SERVICE LETTER

No. 718

Subject: Bendix Magneto Bulletin No. 566 -- reference attached Avco Lycoming Service Bulletin No. 373, dated March 22, 1974.

SUBJECT: S-1200 Distributor Block and Gear Change

Figure 1.

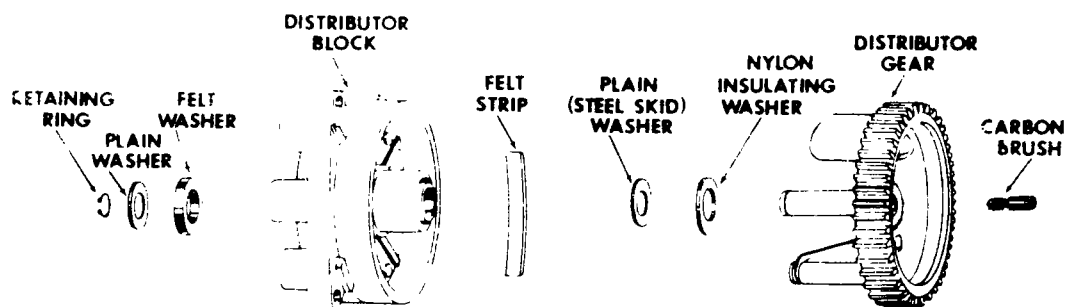
It has been found that the addition of a nylon insulating washer and steel skid washer between the distributor gear electrode and the block bushing, as shown in figure 1, reduces the possibility of deterioration of the lubricant and possible seizure of the parts.

The addition of the washers make it necessary to shorten the gear end of the bushing and block. New production blocks incorporating the change are identified by a raised

Assemble large distributor gear, nylon and steel washers to new or reworked block as follows using figure 1 as a guide.

2. Slide nylon insulating washer 10-391309 and plain washer 10-391511 onto gear shaft.

3. Lubricate inside of bronze bushing with a light film of Bendix Distributor Block Lubricant. ** Insert shaft of gear through distributor block and position plain washer on shaft. Using the 11-3071 Retaining Ring Pliers, install retaining ring on shaft. Rotate gear to insure there is no interference between gear electrode and block electrodes.

Once modified, the distributor block can be used only with a gear having the nylon and steel washer installed over the shaft as shown in figure 1.

Figure 2

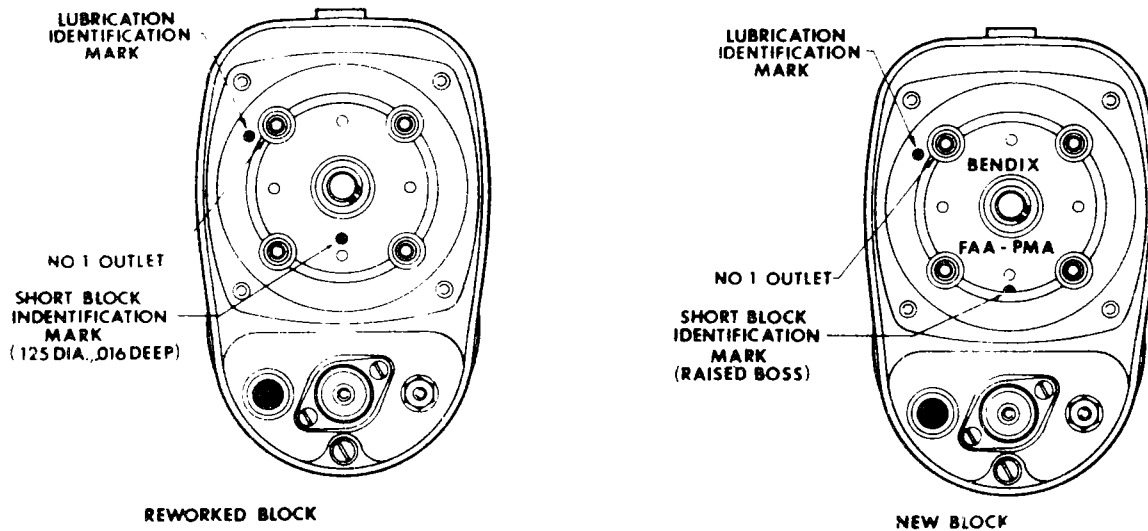
boss between the high tension towers at the six o'clock position and molded in letters as shown in figure 2.

Reworked blocks are identified by a drill point indentation in the same location. New and reworked blocks both have different part numbers from the current (old) block. See Table 1.

7. Identify reworked blocks by drilling a flat bottomed hole .125" diameter and .016" deep in the six o'clock position as shown in figure 2.

(3) Identify distributor block by drilling flat bottomed indentation 0.125 inch diameter and 0.016 inch deep located as shown in figure 2.

Figure 3.

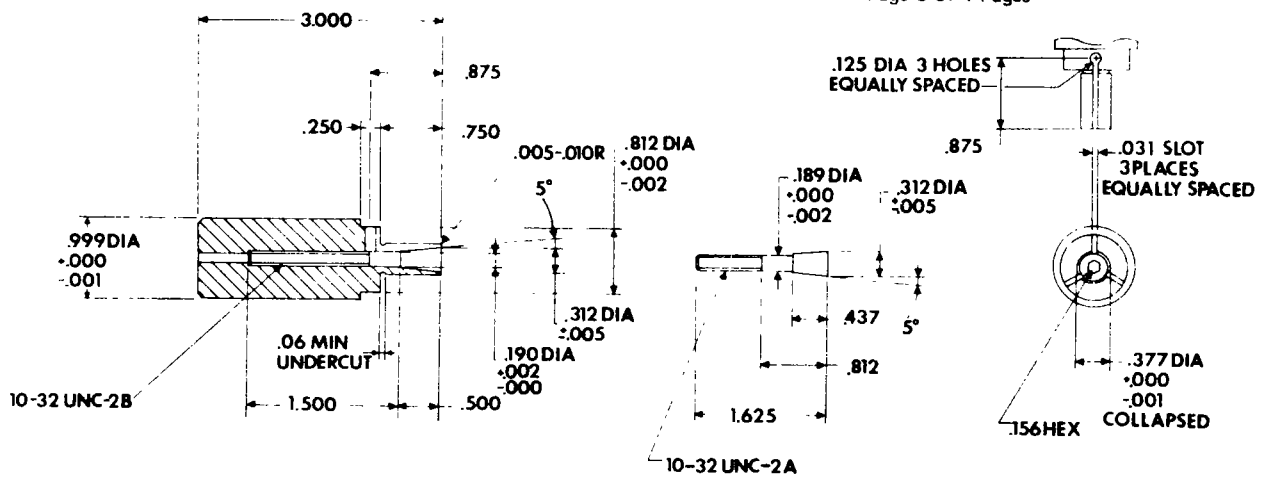
2. Fabricate an expanding arbor lathe fixture as shown in figure 3. (Similar arbors may be purchased from industry machine tool supply houses.)

3. With arbor in lathe, slide distributor block over arbor, high tension outlet tower side first, until block bushing bottoms on arbor shoulder. Tighten arbor expansion screw until block is held securely for turning operation.

Expanding arbor lathe fixture. (See figure 3).

Figure 4.

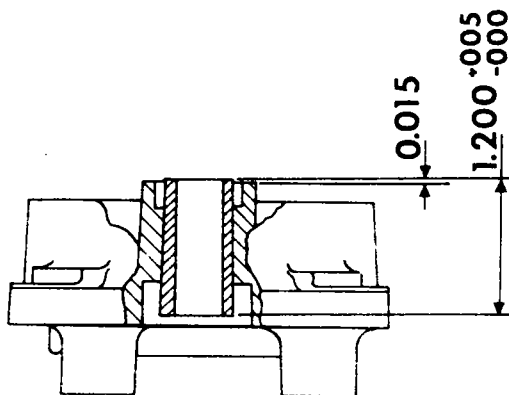
4. Use a suitable cutting tool and turn so that overall length of bushing is $1.200 + .005 - .000$ inch as shown in figure 4. (A Carbaloy tipped tool is recommended.)

5. Using same cutting tool, turn dielectric material of block so that resulting surface is .015 inch below end

of reworked bushing. See figure 4.
